EPA Oral Hearing, Bracken Court Hotel, Balbriggan – 28 April 2009 (Slide 1)

Re: Fingal Landfill Project

Statement of Evidence

Pathways - Groundwater Head Contour Plot

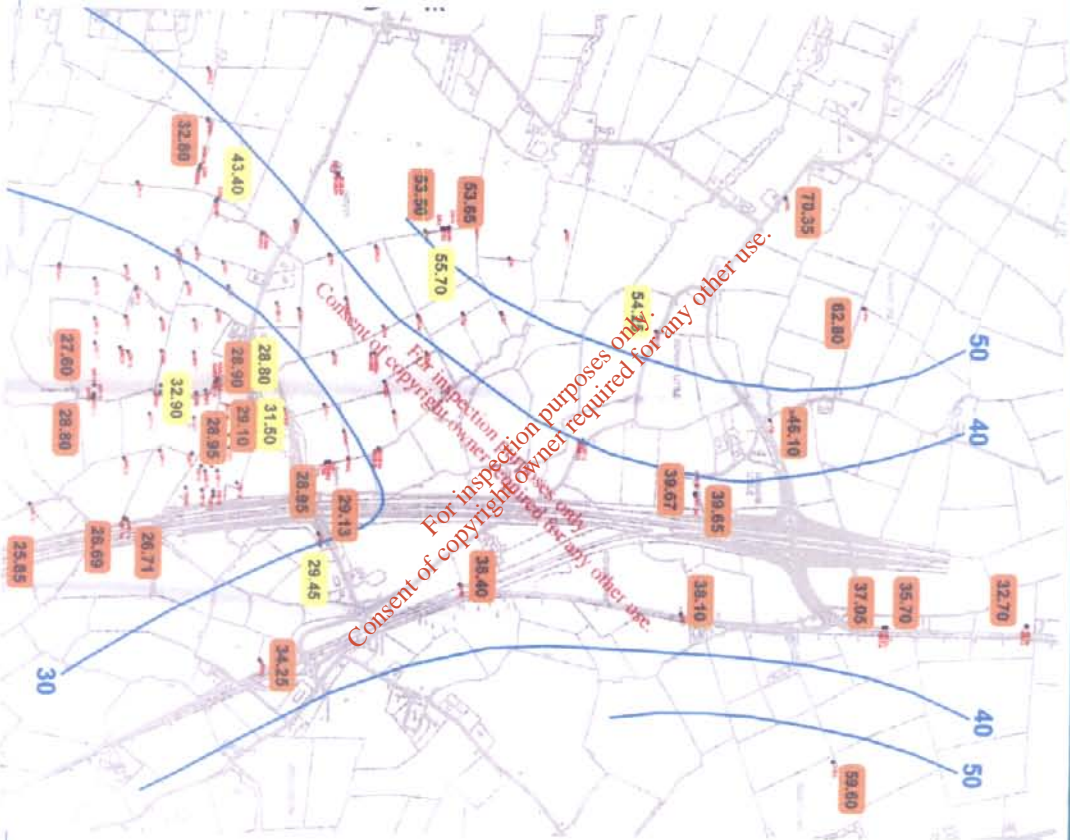
Although individual groundwater dip readings were not included in the submission, hydrographs (graphs showing water level fluctuations) contained in the submission, allow the estimation of selected groundwater levels in boreholes across the site. It appears that the shallow drift water table in general, approximates the underlying piezometric surface (i.e. water pressure elevation) from the Gravel/Bedrock aquifer (this applies to shallow drift holes (ER13, ES2, HR9, GS6, ASA2, GS2). Given the data available, the only observed exception to this is for monitoring location ES8, where the shallow drift groundwater elevation can be in the order of 10 m above the hydraulic head in the underlying Gravel/Bedrock unit in the vicinity of this hole. This could mean that from these data, only the groundwater elevation at location ES8 may be best described as perched. This suggests that the hydraulic interaction between the shallow drift and underlying Gravel/Bedrock aquifer, and indeed the permeability of the shallow clay rich drift unit as a whole, would be better understood by further comparison of these levels across the site. Such detail is lacking within the HRA submission, but again judged to be of fundamental importance to a landfill risk assessment for this site setting. In our opinion, more information is required across this extensive site footprint (in the order for 57 hectares) to allow for adequate characterisation of groundwater elevations in the shallow drift, than that provided in the submission. We believe that the data provided in evidence yesterday by the applicant at the Oral Hearing (27/04/09) strengthens our view that hydraulic head within the drift approximates, and is strongly influenced by, the aquifer piezometric surface. Both adopt a similar attitude and fall to the southeast across the site. (Slides 5 & 6)

Pathways - Groundwater Head Contour Plot (inc. shallow drift)

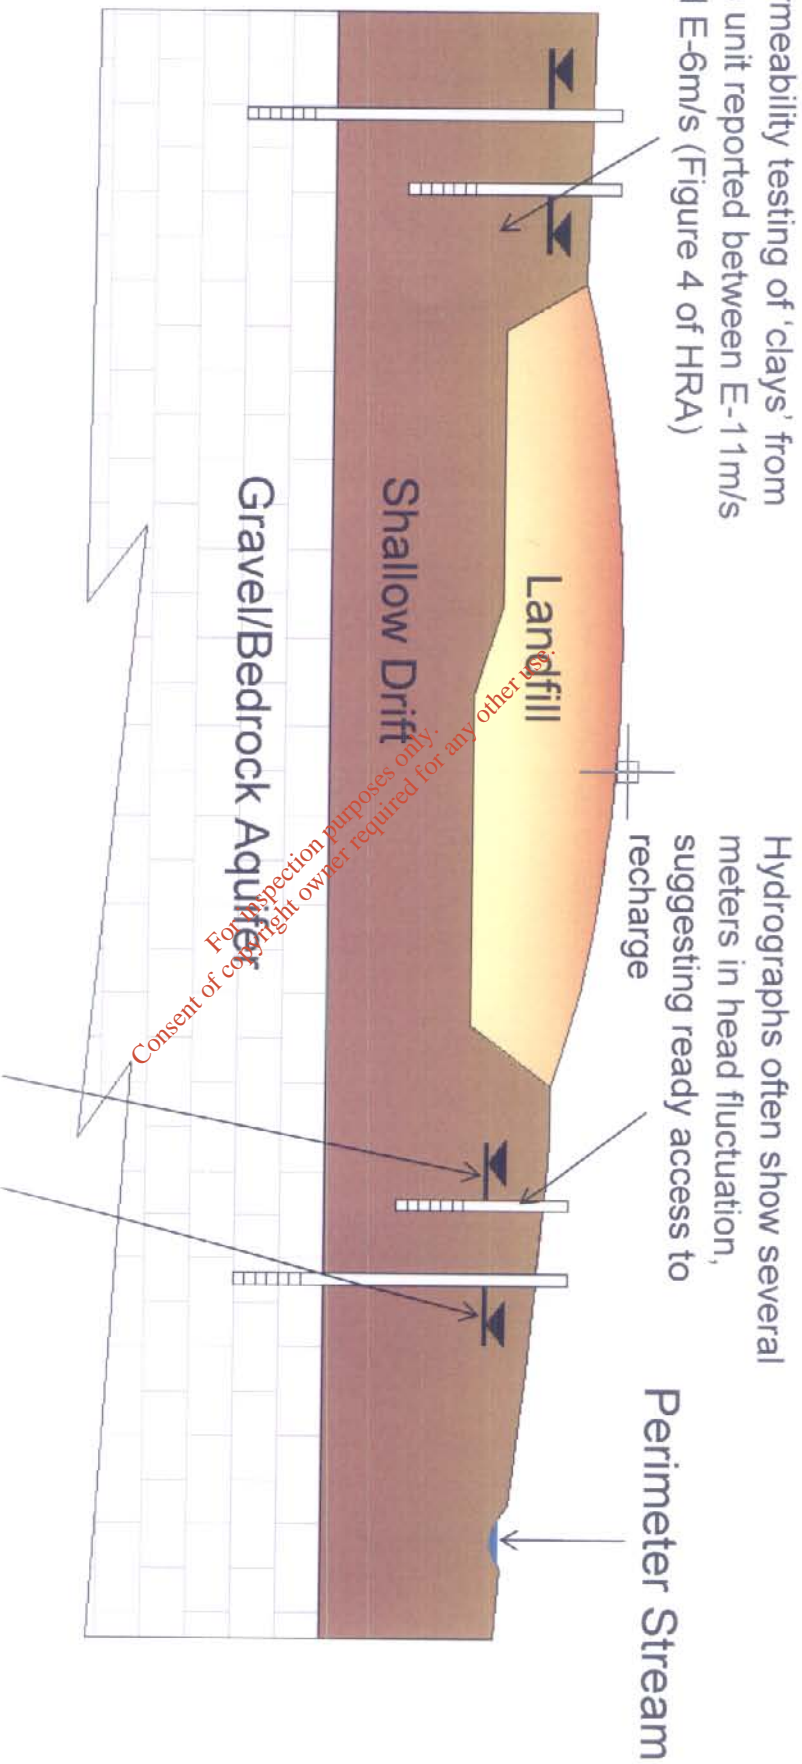
Similar groundwater elevations in neighbouring boreholes suggests shallow drift is expected to be saturated by virtue of the hydraulic head in the Gravel/Bedrock aquifer – some variations to the levels in both being expected to be driven by recharge events, strata heterogeneity, and 'delayed drainage' in the less permeable shallow system to the perhaps more rapid fluctuations in the deep system

Pathways – Schematic section of shallow and deep

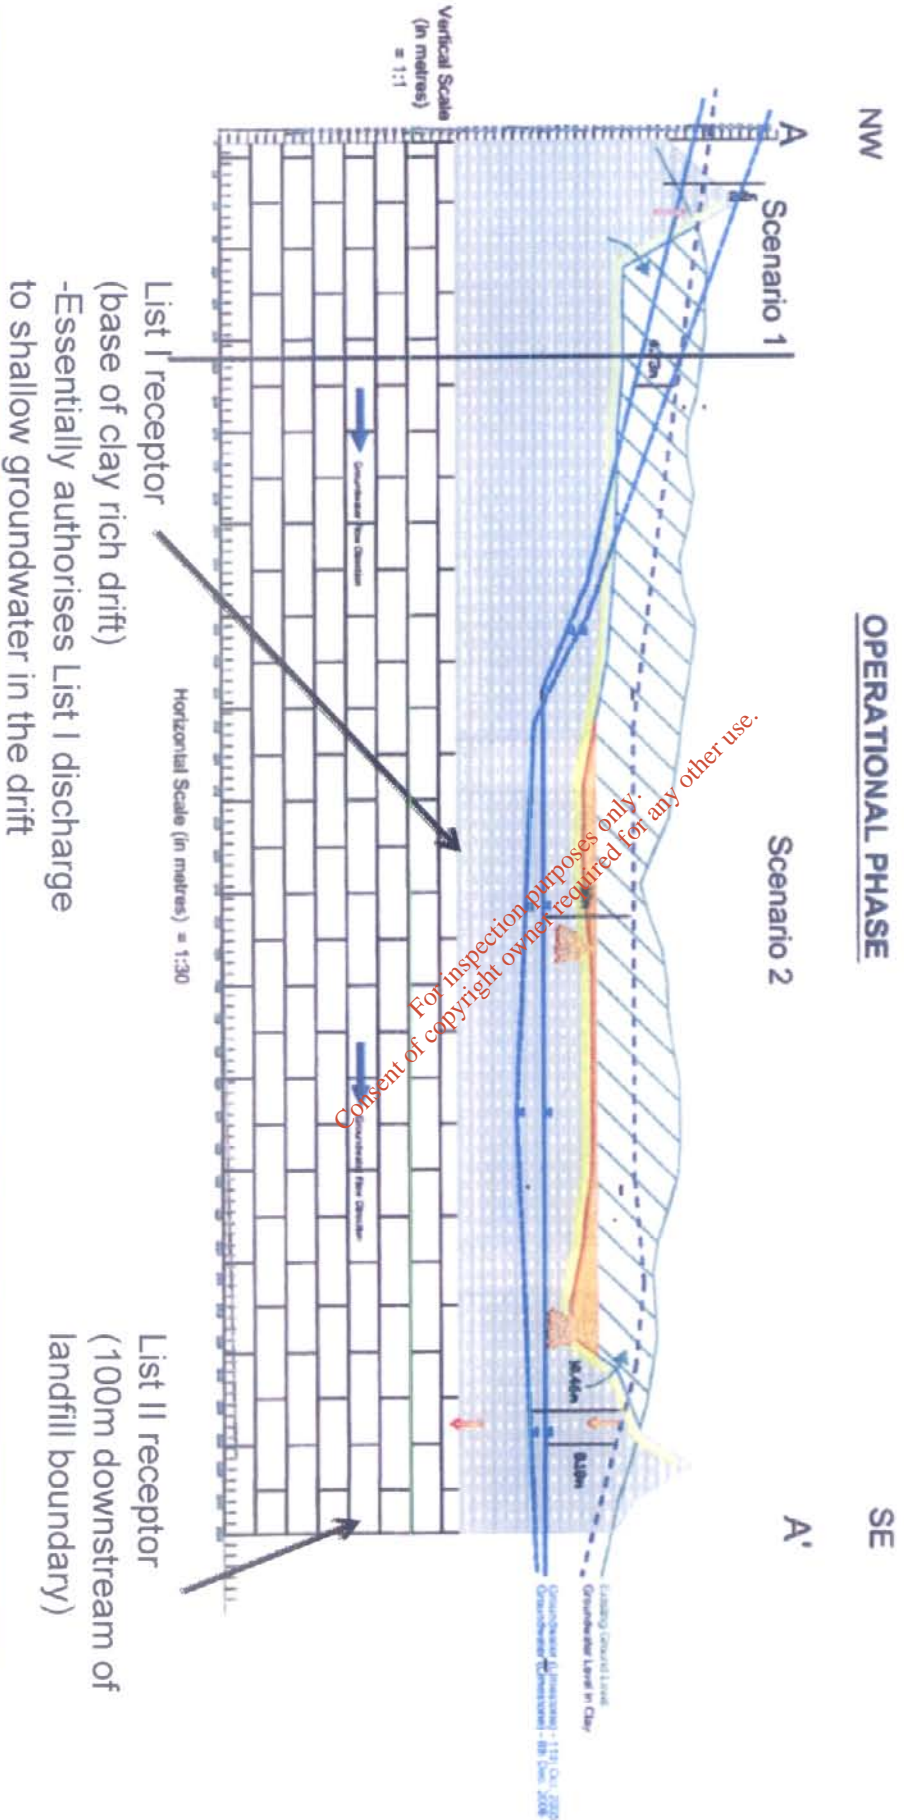
As a minimum, we would have expected to see further analysis of all the shallow drift groundwater elevation data and its behaviour with respect to rainfall, and hydraulic head fluctuation in the Gravel/Bedrock aquifer within the HRA. In addition several detailed hydrogeological cross-sections produced for the development area highlighting individual sand and gravel bands within the drift in particular would have been beneficial. The potential implications are that the clay rich drift unit could be better interpreted as a leaky confining layer rather than containing a perched water table, or indeed isolated disconnected perched groundwater bodies. The leaky confining model would suggest saturation of the shallow drift is strongly influenced by hydraulic connection with the Gravel/Bedrock system. It is simply not credible to conclude that the saturation state of shallow clay rich drift observed will not be influenced by virtue of the underlying hydraulic pressure within the Gravel/Bedrock (which is in the order of 10m above the base of the shallow drift and Gravel/Bedrock interface), while at the same time modelling vertical downward seepage through this unit driven by a 1m leachate head contained within an engineered HDPE membrane.

Furthermore, the drift's permeability may be greater than that defined by the individual slug and clay sample testing presented. Failure to properly understand the shallow groundwater relationship could lead to a misinterpretation of the 'Groundwater' status as recognised by the Groundwater Directive (see below). (Slide 7)

Permeability testing of 'clays' from this unit reported between E-11 m/s and E-6 m/s (Figure 4 of HRA)

Receptors – those considered include

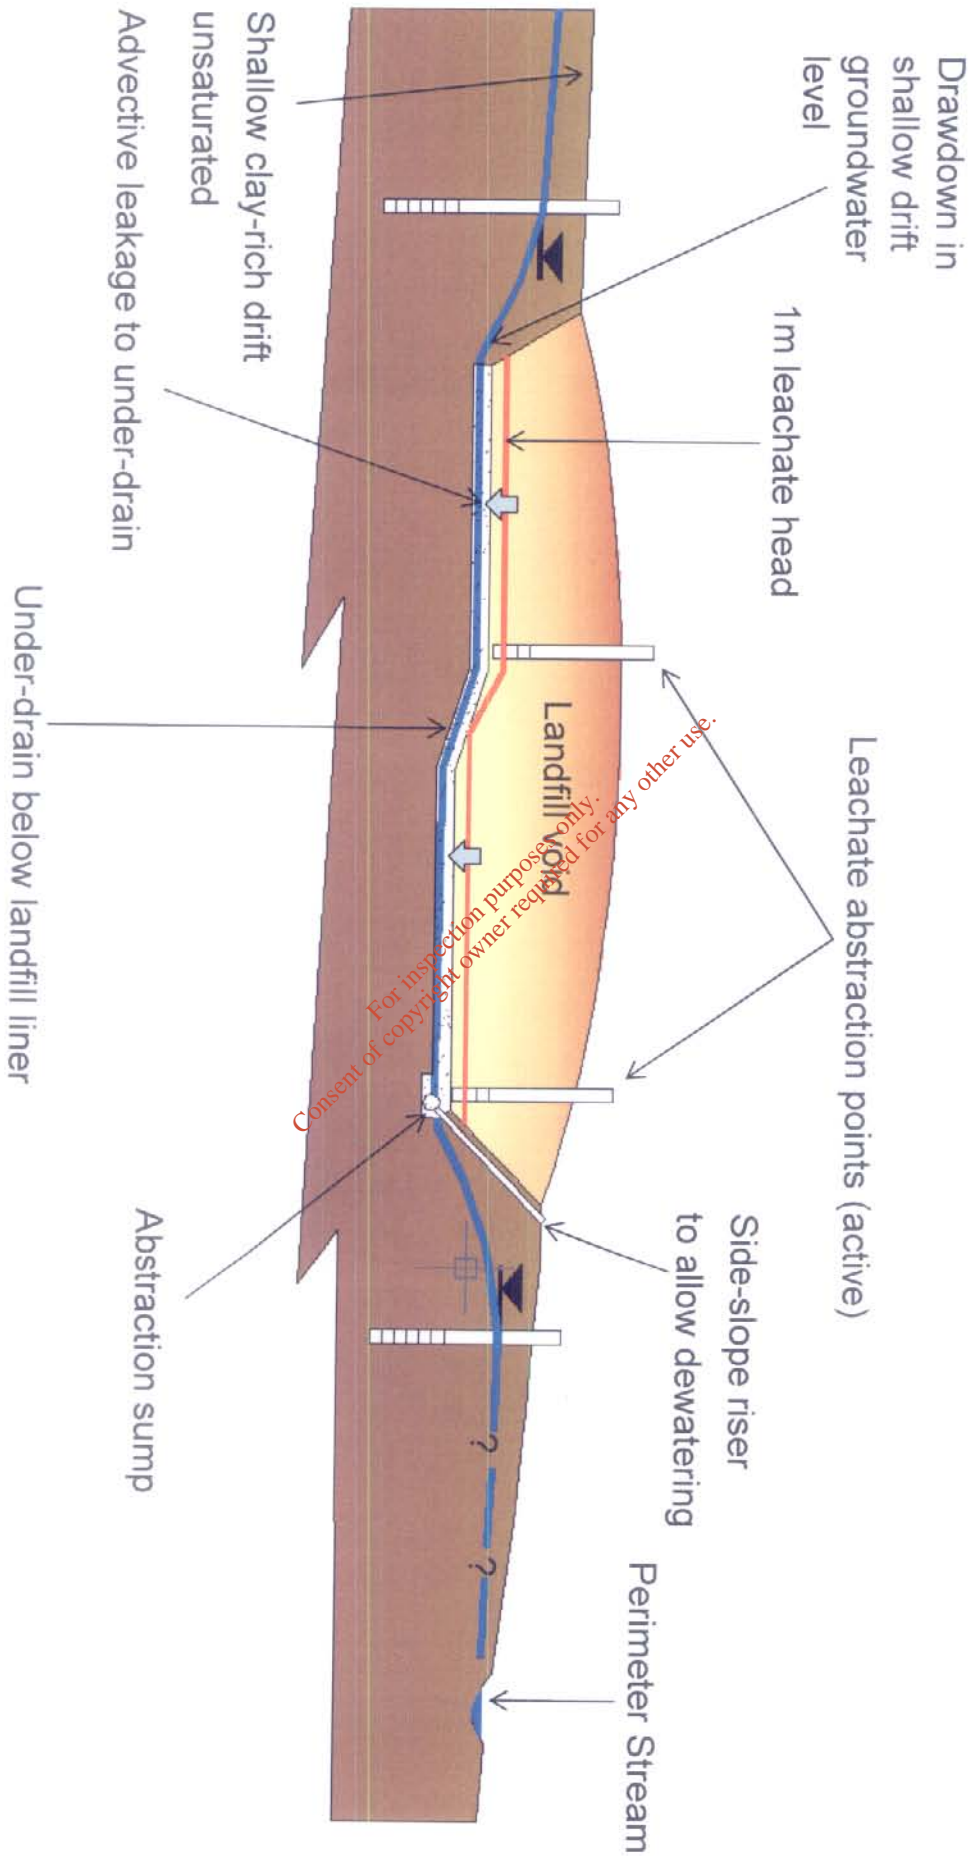
Groundwater within the clay rich drift is viewed by the applicant as a pathway only within the submission and not as a receptor. The Groundwater Directive and Water Framework Directive state that 'Groundwater' means all water which is below the surface of the ground in the saturation zone and in direct contact with the ground or subsoil. The Directive also states that the discharge of List I substances to groundwater is prohibited. We have seen no justification to support the fact that the 'perched' water table as it is described within the drift (Figure 3.18.7 of the EIS and Figure 006 of the HRA) does not meet the above referenced specification, and therefore that List I substances can be legitimately discharged to this water. Concentrations were modelled and reported at the base of 10 m of clay drift and but have not been presented prior to entry into the drift groundwater. We are unaware of any sites in Ireland, or indeed the UK, where the release of List I substances has been authorised, to what is described by the applicant in the EIS, as a groundwater table.

In general, and at the desk study stage, landfill site location policy is linked to aquifer status. However, following site selection, and at the site specific risk assessment stage, a robust demonstration that groundwater quality will be protected is required regardless of the aquifer status. In effect, at this stage all groundwater bodies are considered equal and all worthy of protection. (Slide 8)

Consideration of landfill development – early Operational Phase

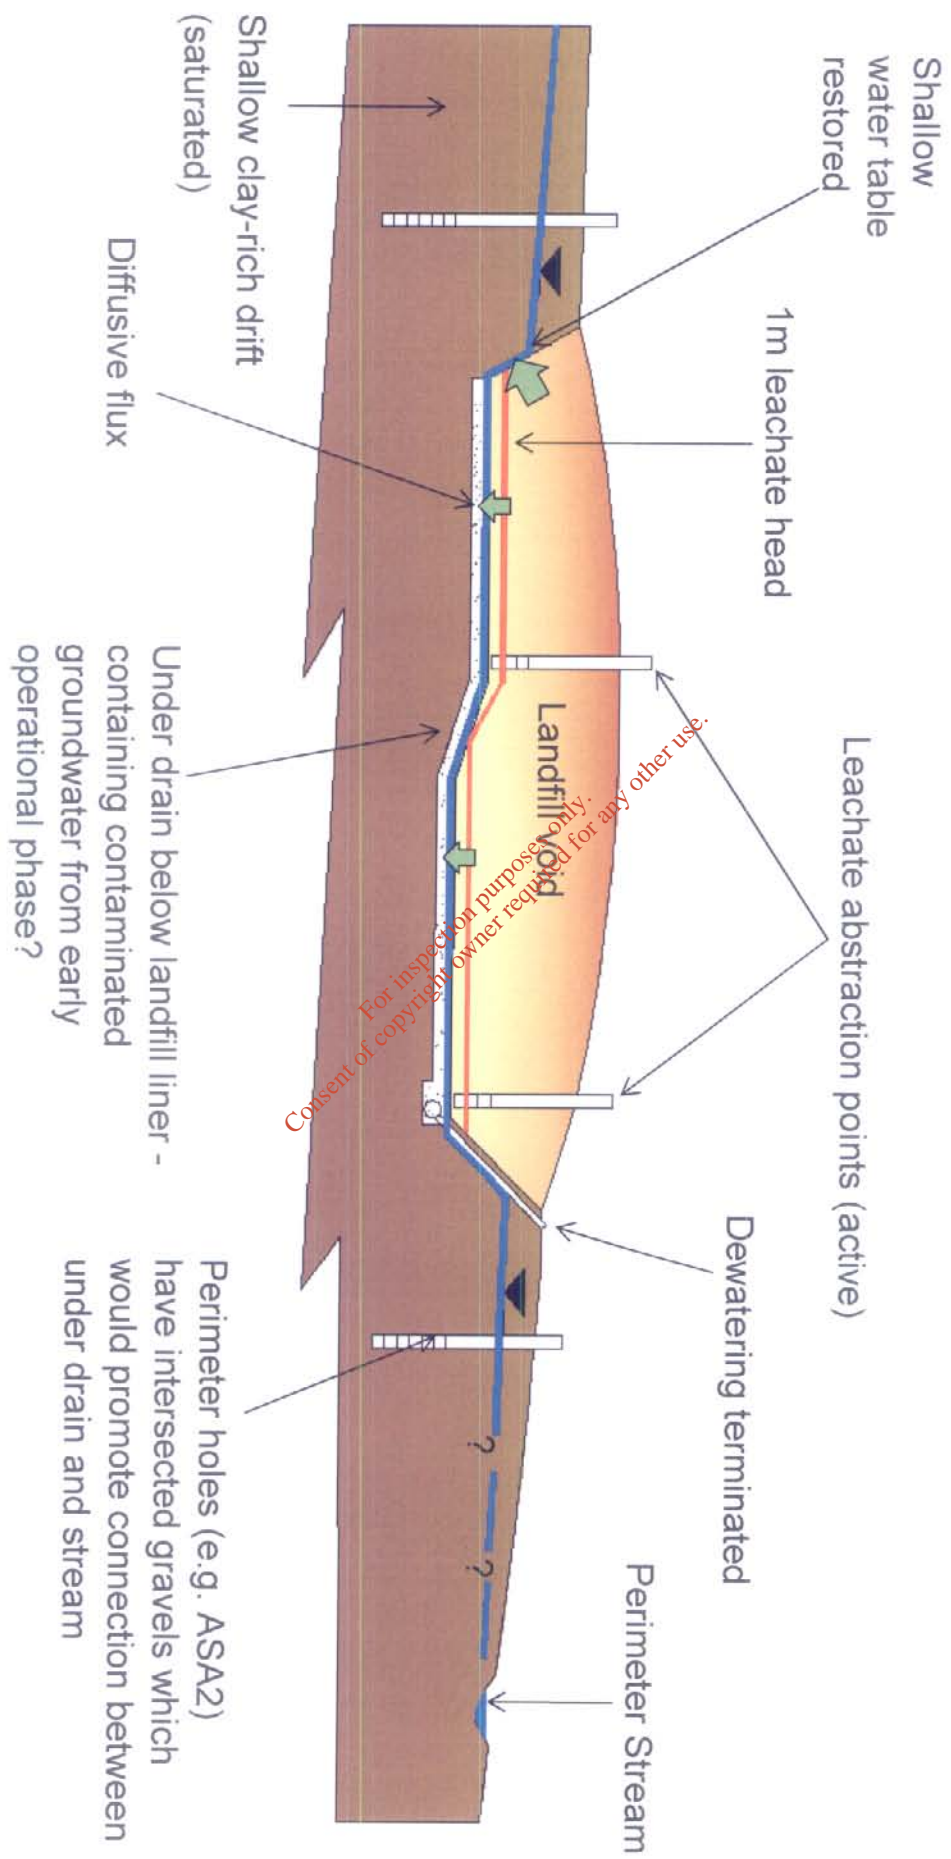
None of the scenarios deal with the likely consequence of the site design incorporating an under drain (below the liner). If drift boreholes are showing groundwater levels above the proposed liner elevation in the site (described in the HRA Executive Summary), it is fair to assume that a large excavation into the drift to allow for liner emplacement will require dewatering during construction and during early operations and filling at the site. During the early operation of the landfill, any contamination leaking from the site will presumably be drawn out from the under drain. No indication has been observed as to the likely water quantity or quality from the under drain or what plans exist to manage and treat this water. Uncertainty remains regarding whether or not uncharacterised contamination deriving from the current illegal tip on the site will be drawn to this system. It was demonstrated at the previous EPA Oral Hearing in March 2008 that inadequate site investigation was undertaken at what is potentially the largest illegal dump discovered in Ireland to date. The extent of the dump and the nature of the waste contained in the dump remains unknown (Slide 9).

Development of a high permeability under drain layer below the footprint will encourage contaminants to move laterally below the floor of the site and above the underlying less permeable materials. The modelling and assessment undertaken by the applicant has not examined this aspect within the HRA.
